**Florida Department of
Environmental Protection
Inspection Checklist**

Facility Name: SOUTHEAST COUNTY SLF (PICNIC LF)

On-Site Inspection Start Date: 05/24/2019

Routine Operation Inspection for Landfill - Class I

Leachate Cut-off Trench Extension

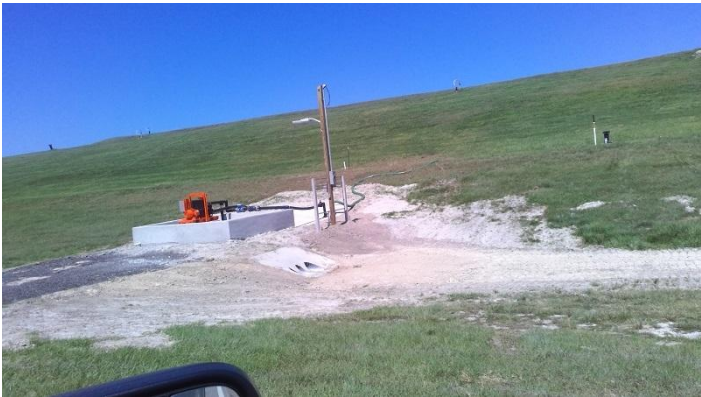
An extension project for the leachate cut-off trench at the southeast corner of Phase II was underway at the time of inspection. The project was to extend the leachate cut-off trench further west to the the Phase I boundary. At the time of inspection, the trench extension had been already been excavated, installed with piping, and backfilled, awaiting restoration of vegetative cover.

Permanent PS-2 Under Construction

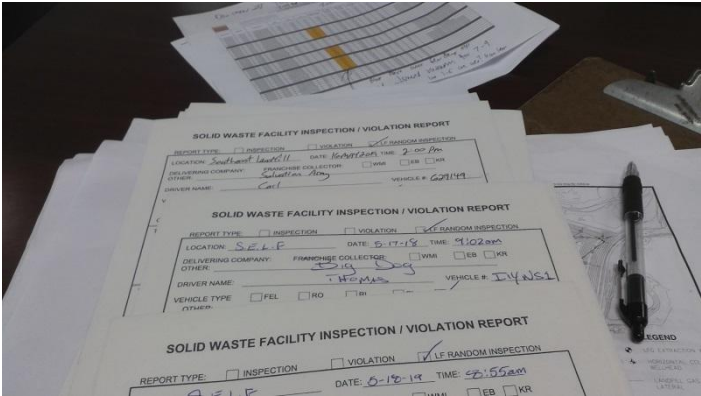
A permanent pump station, PS-2, to service the leachate cut-off trench was under construction at the time of inspection. A temporary, mobile pump station was in use instead at the time of inspection.

Annual Waste Tire Fire Inspection

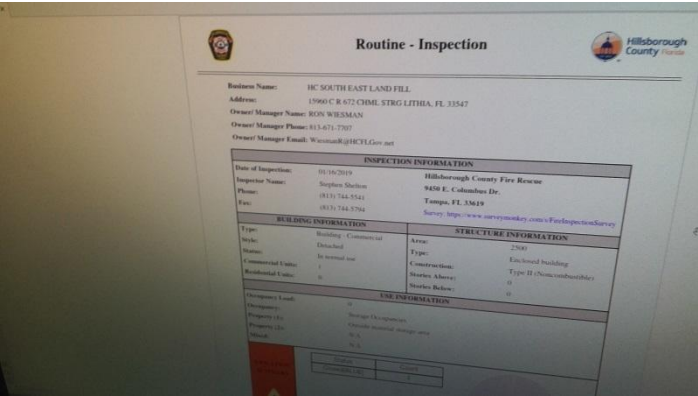
9.10 / 9.11: Electronically kept records of a fire safety inspection performed 1/16/2019 were reviewed on-site during the inspection. This fire safety inspection report was previously submitted to the Department on 2/21/2019.
